Dellcool refrigerator light

Bulletin Type:	TSB	Publication Date:	April 16, 2021
Bulletin #(s):	21-008	Make(s):	Jayco
Job Code(s):	9801567	Model(s):	Jay Flight SLX
Flat Rate(s):	.25 HR	Model Year(s):	2021

Pic. 3

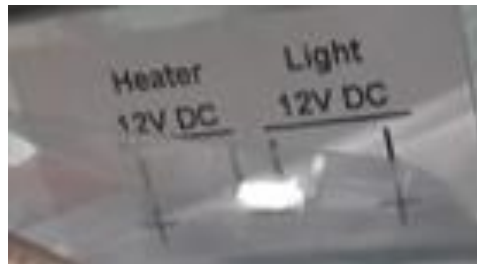
Incident:	12 Volt interior light activated by opening the door was not wired to the back of the Dellcool refrigerator.
Affected Units:	M77D0273 – M77D0320 M77J0393 – M77J0410 M77A0219 – M77A0266 M77E0249 – M77E0296
Misc. Tools & Supplies:	Wire Stripper/Crimpers 3" Piece-12 AWG / 12 Gauge orange wire 2 ea. - 12 AWG / 12 GA. insulated female spade terminals.

1. Cut 3" section of orange 12 AWG / 12-gauge wire.
2. Depending on the size of the 12 AWG / 12-gauge insulated female spade terminal barrel, strip the correct length of insulation from the end of the 12 AWG / 12-gauge wire, using a wire stripper.
3. Crimp 12 AWG / 12-gauge insulated female spade terminal to each end of the stripped orange wire.
4. Install Jumper wire from Heater (+) positive terminal to Light (+) Terminal. Reference Legend.
5. Repair is complete. **Pic. 3**
